NJPR-12-0043

**Missing Seismic Walkdown Checklist (SWC)**

Equipment ID No. T4100B009 Equip. Class<sup>1</sup> 11, Chillers

Equipment Description CCHVAC North Div 1 Air Conditioner Chiller

Equipment Description CCHVAC North Div 1 Air Conditioner Chiller

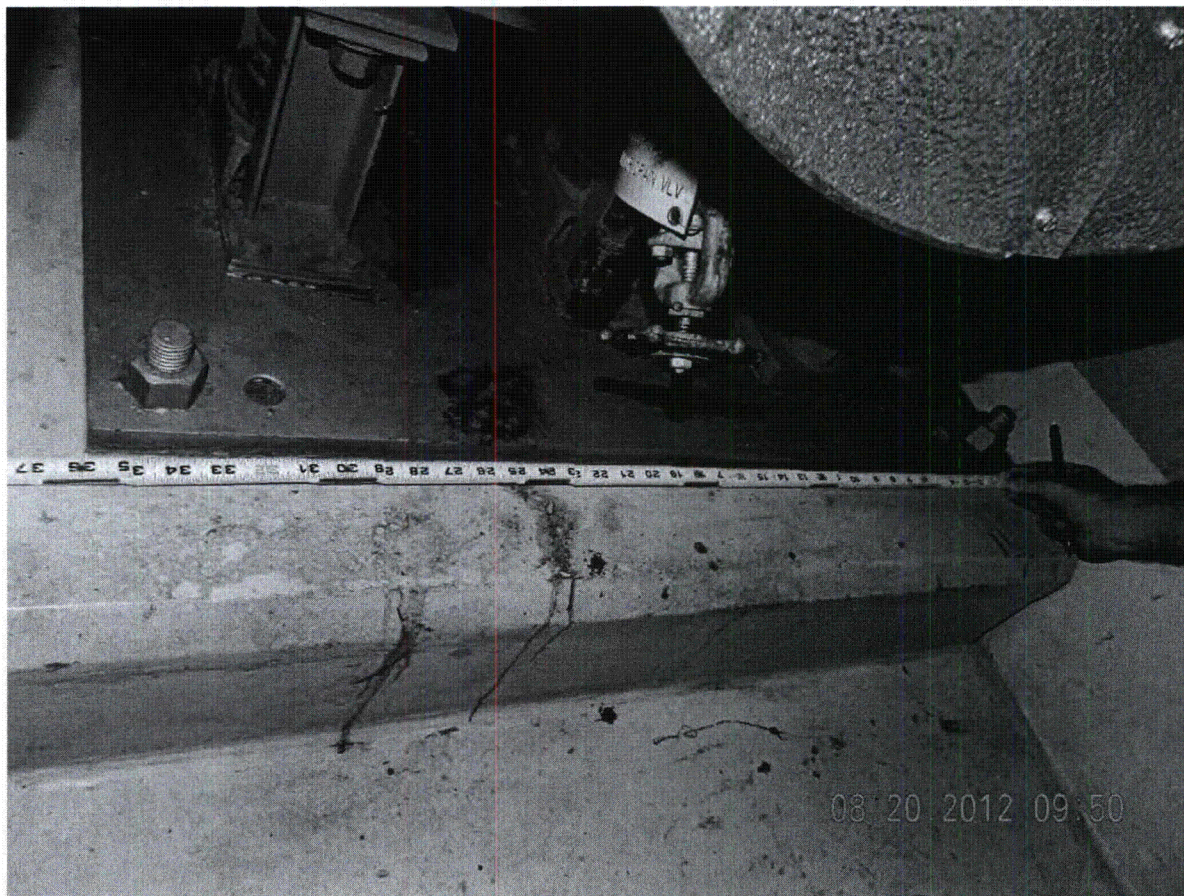
2. Is the anchorage free of bent, broken, missing or loose hardware?  Y  N  U  N/A  
*All bolts installed properly. Missing spring isolator bolt at SE spring isolator; See CARD 12-28245 for action. See photos DSCN0558-0569 and DSCN0576-0579.*

5. Is the anchorage configuration consistent with plant documentation?(Note: This question only applies if the item is one of the 50% for which an anchorage configuration verification is required.)  Y  N  U  N/A  
*Anchorage is consistent with drawing M-4007. Missing spring isolator bolt at SE spring isolator (See question No. 2)*

6. Based on the above anchorage evaluations, is the anchorage free of potentially adverse seismic conditions?  Y  N  U  
*The missing spring isolator bolt and questionable clearance at spring isolators are potentially adverse seismic conditions. Refer to CARDS 12-28245 and 12-28393 for resolution of the conditions.*

(DSCN0574)

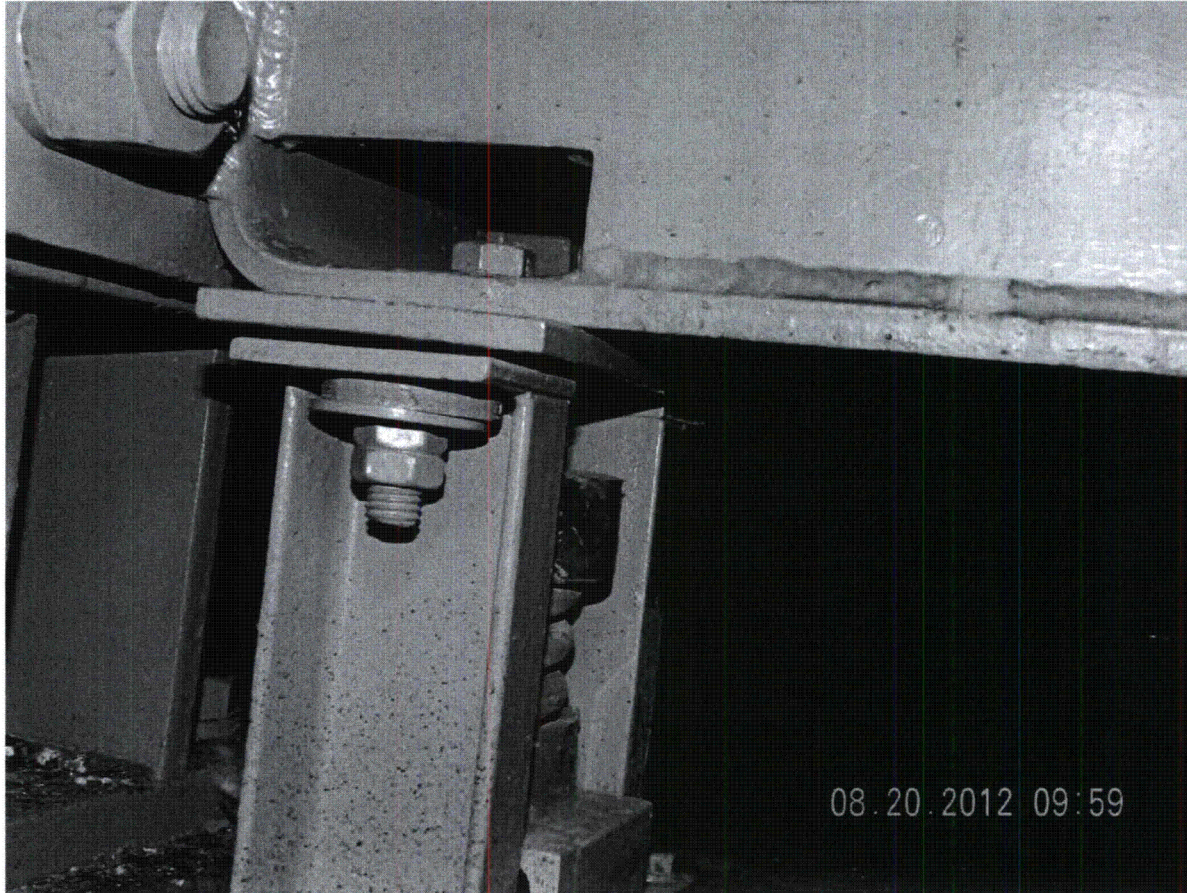
*Isolator clearance at some locations appears insufficient. Minimum clearances are not specified on the drawings or vendor documents. See CARD 12-28393 for action. See Photo DSCN0574.*

Seismic Walkdown "Hand Calculation"

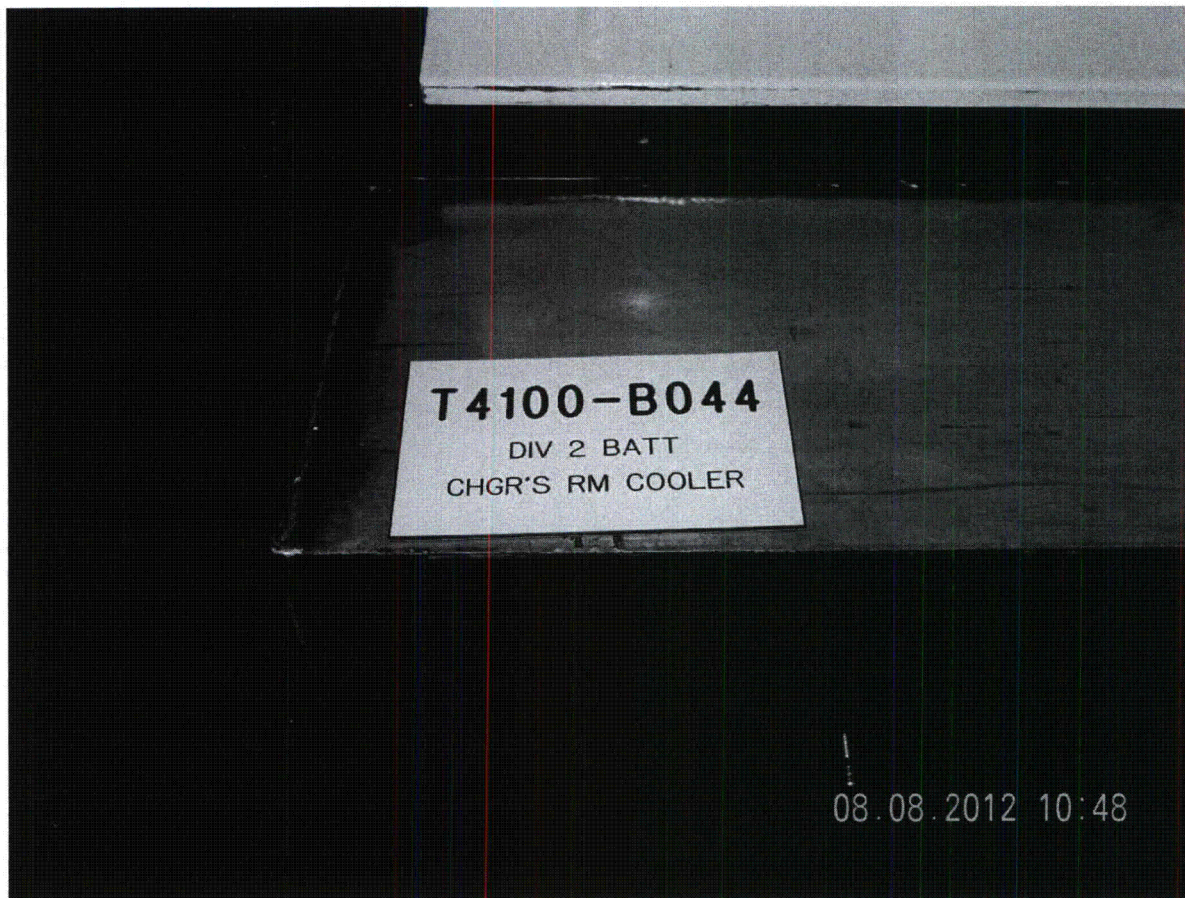
6. Based on the above anchorage evaluations, is the anchorage free of potentially adverse seismic conditions?  Y  N  U   
*Possible rattle space violation with 1"Ø conduit to TSE-T41-N452 (see photo DSCN0163). Note: See attached hand calculation for resolution. Rattle space is sufficient.*  
(SEE PICTURE DSCN0169) ~ DJK 10/11/12

11. Have you looked for and found no other seismic conditions that could adversely affect the safety functions of the equipment?  Y  N  U  
*Possible rattlespace violation with 1"Ø conduit to TSE-T41-N452 (see photo DSCN0163). Note: See attached hand calculation of maximum frame deflection. Rattlespace is sufficient.*

GIVEN:  
 5% DAMPING (LFSAR TBL 3.7-2, WELDED STRUCTURE)  
 FRAME WEIGHT W1 = 268#  
 (SEE D108-6302 SHEETS 1-3)  
 FAN COIL WEIGHT W2 = 880#  
 (SEE D108-0002, NOTE 5)  
 SA = 1.7 (LFSAR FIG. 3.7-63, 5% DAMPING, PEAK OF GRAPH (CONSERVATIVE))

$[\Delta_{max} = 0.61"] \ll [\Delta_{ALLOWABLE} = 0.75"] \therefore \text{OK}$
